Item No. 3 Subdivision and Rezoning – 1914 Henderson Highway (North Kildonan Ward) File DASZ 17/2015 [c/r SPA 4/2015 & DAV 130129/2015D]

Title: DASZ 17/2015, 1914 Henderson Highway

Issue: application for approval of a proposed plan of subdivision and rezoning to create one lot and widen the Henderson Highway Right-of-Way and to rezone the proposed lot from "R1-E" Residential Single-Family Estate to "RMF-M" Residential Multi-Family Medium

Figure 4: Conceptual Site Plan of Proposed Development, 2014 Aerial Photography **North↑**

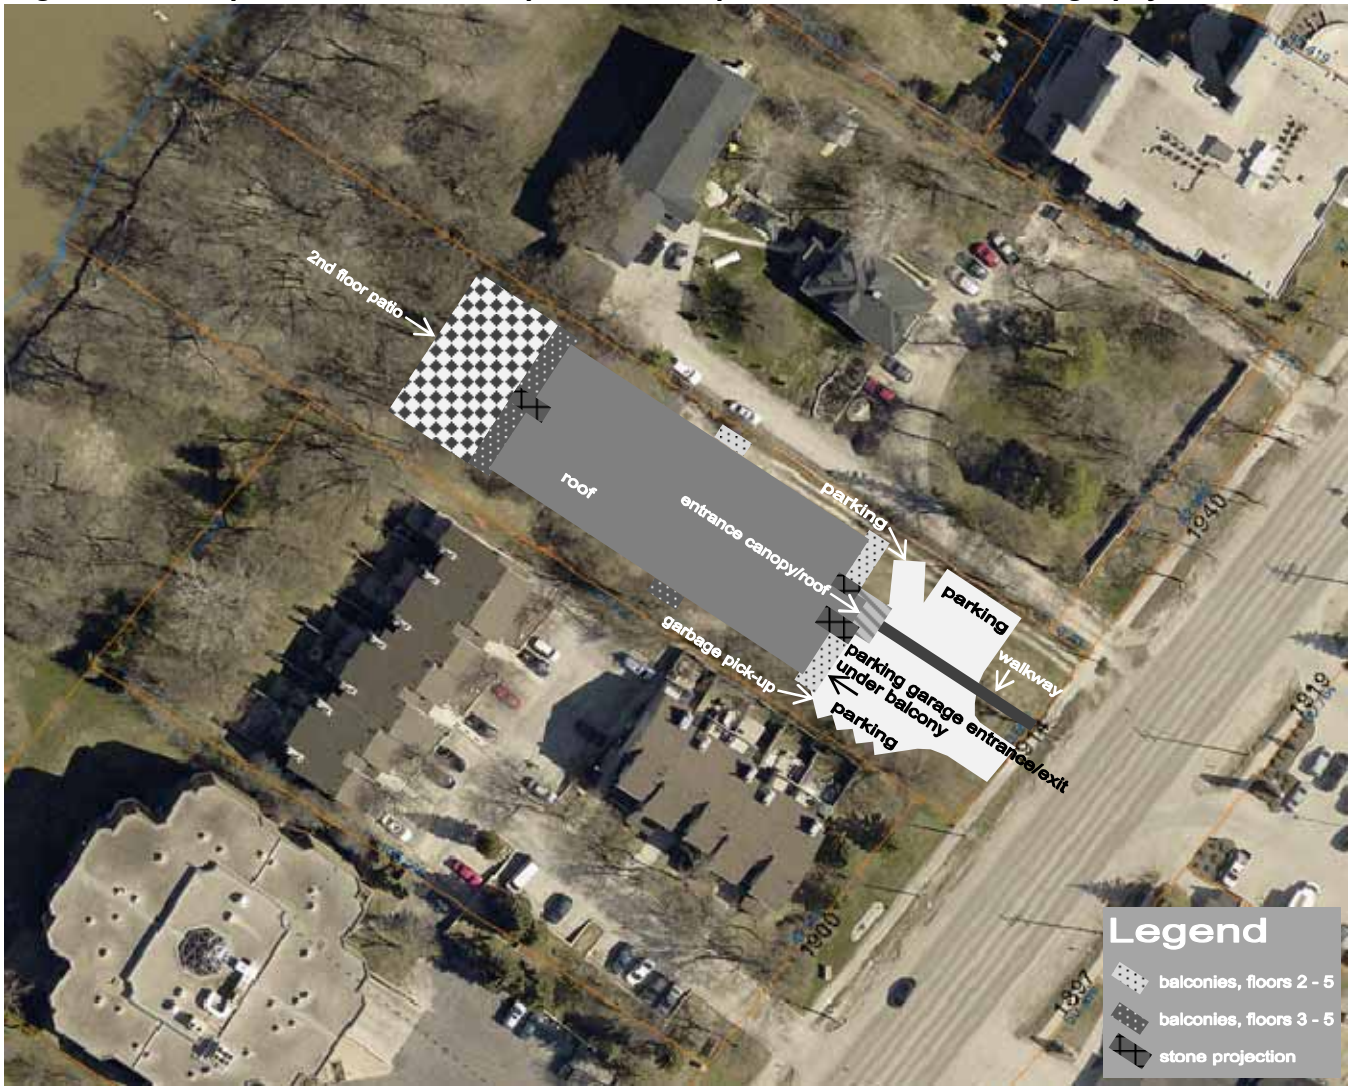
Regarding the two site plans, version "a" is more compatible with the property to the north and version "b" is more compatible with the property to the south. Given that the rear yards of five townhouses to the south are abutting the subject site, the development should be closer to the northern limit of the site than the southern limit. However, space should be provided for a fence between the northern limit of the site and the outside parking area.

This could be achieved with a north side-yard, measured to the proposed building's exterior wall, of 9.5 feet (in depth) and a corresponding south side-yard depth of 17.5 feet deep, as illustrated conceptually on Figure 4. This would result in the outside parking area being 0.5 feet south of the northern site limit and approximately four feet from the southern site limit. These side-yard depths, and sufficient landscaping along the south side of the outside parking area, can be assured by modifying Variance Application DAV 15-130129D and approving the variance application as modified.

Schedule "A" for File DASZ 17/2015, East Kildonan – Transcona Community Committee, dated November 6, 2015

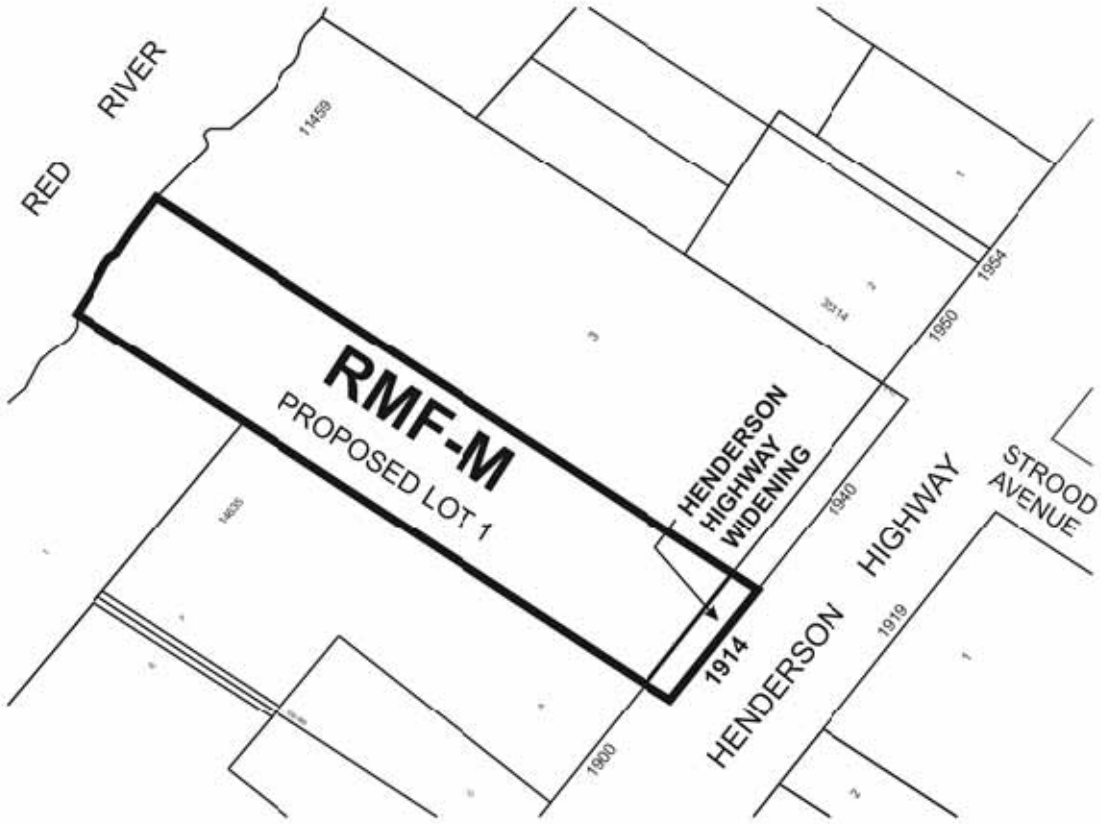
The recommended condition to approve the subdivision and rezoning in accordance with Schedule “B” instead of what was proposed (and shown on Schedule “A”) is to ensure the proposed subdivision and rezoning will be consistent with *OurWinnipeg* and *Complete Communities* and generally compatible with the area.

3) That Schedule A be replaced with Schedule B, to include the establishment of a Public Reserve parcel along the riverbank, the specific limits of which shall be an alignment consistent with and connecting the east limit of the Public Reserve parcel to the south with the Public Reserve parcel further north as determined and approved by the Director of Property and Planning.

Schedule "B" for File DASZ 17/2015, East Kildonan – Transcona Community Committee, dated November 6, 2015

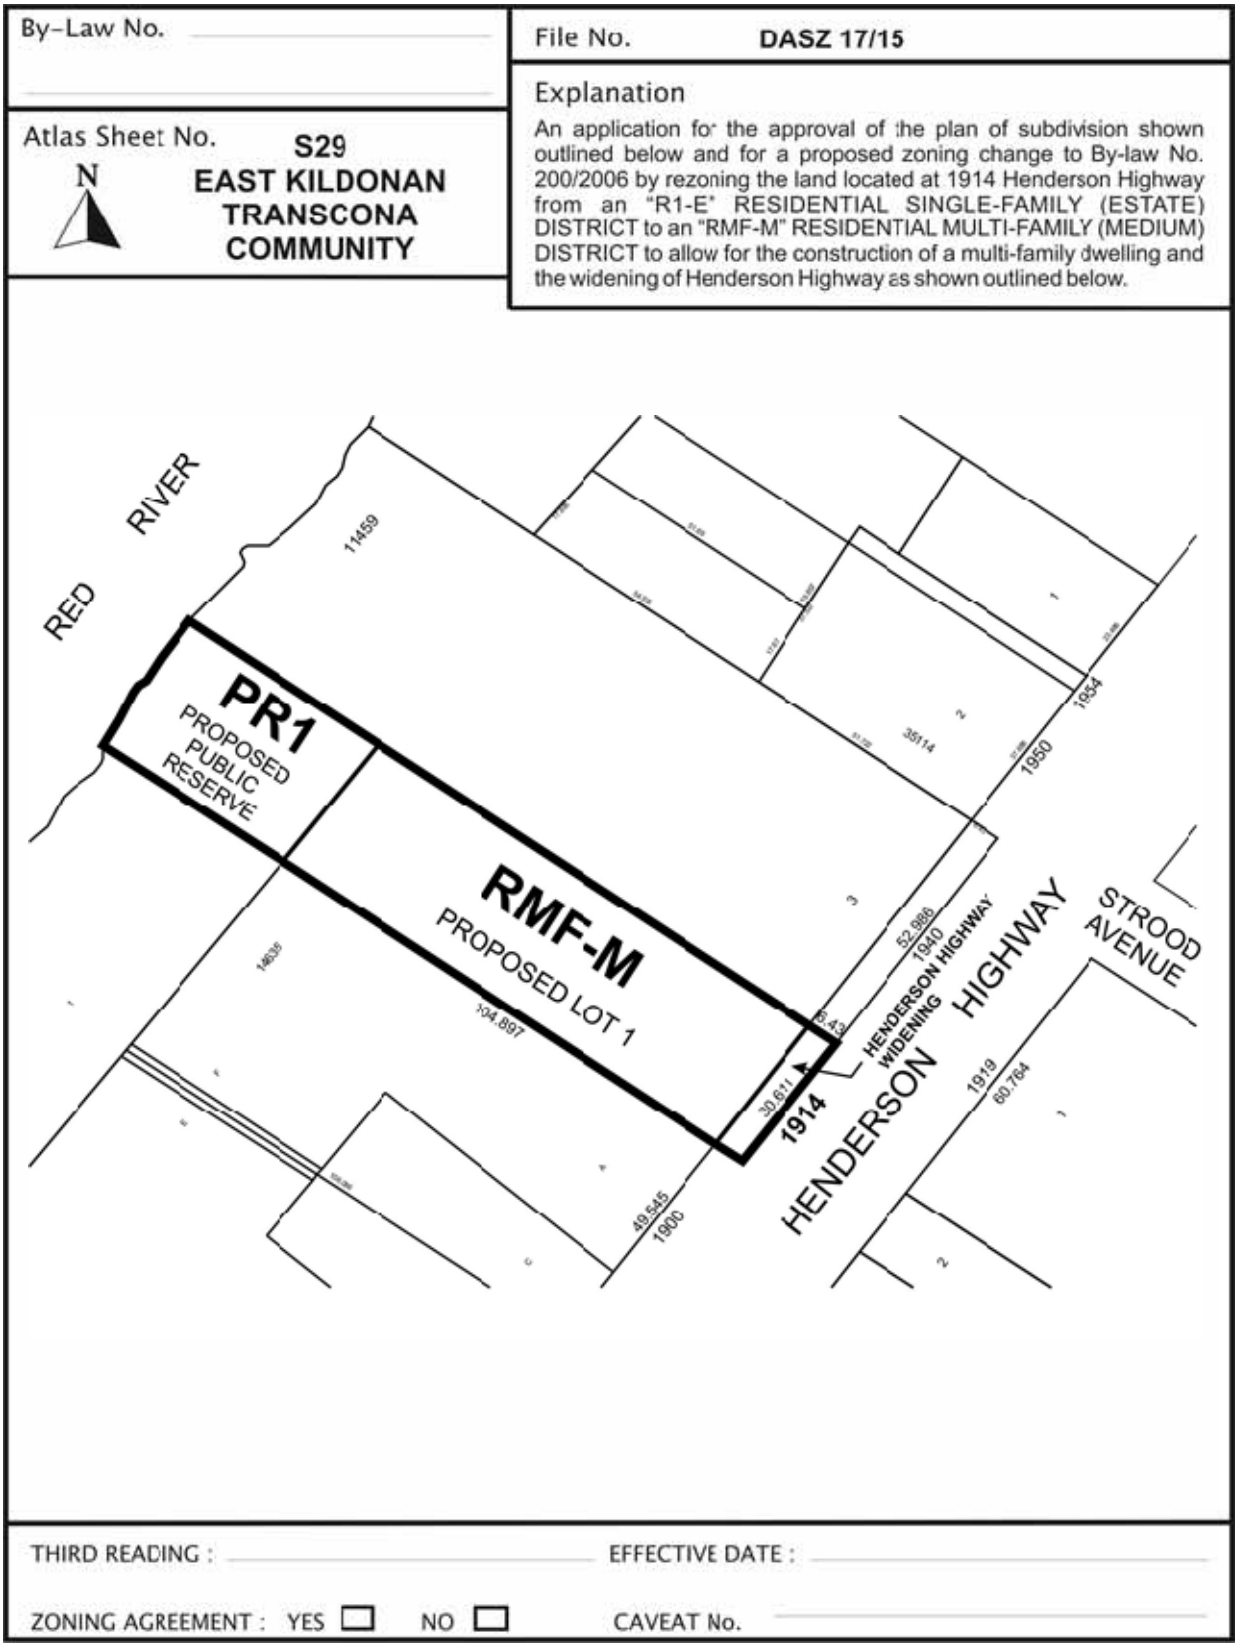
options." If the proposed subdivision and rezoning is modified such that the rear portion of the subject site becomes a public reserve that is zoned "PR-1," as shown on Schedule "B," another segment of land would be added to the Kildonan Parkway, which is consistent with this Key Direction.
In addition, *Complete Communities'* Section 07, Direction 3, the fourth policy, states: "Protect and enhance public access to our riverbanks…" If the proposed subdivision and rezoning are modified such that the rear portion of the subject site becomes a public reserve that is zoned "PR-1," it would comply with this policy as well.

4) The Developer shall at no expense to the City address any damage or impacts to the proposed Public Reserve area resulting from the development of the RMF property. This could include the provision of grading and sodding if required to ensure positive drainage and smooth transition for any grade changes between the two properties as determined by and to the satisfaction of the Director of Public Works.

5) The Developer shall at no expense to the City provide property line delineation between the public and private lands, in the form of a fence, which at a minimum may be bollards spaced equally starting from the north property limit to the south, approximately 20' on centre. Said fence shall be located on the private property and established by caveat to become the ongoing responsibility of the property owner for maintenance, repairs and replacement.
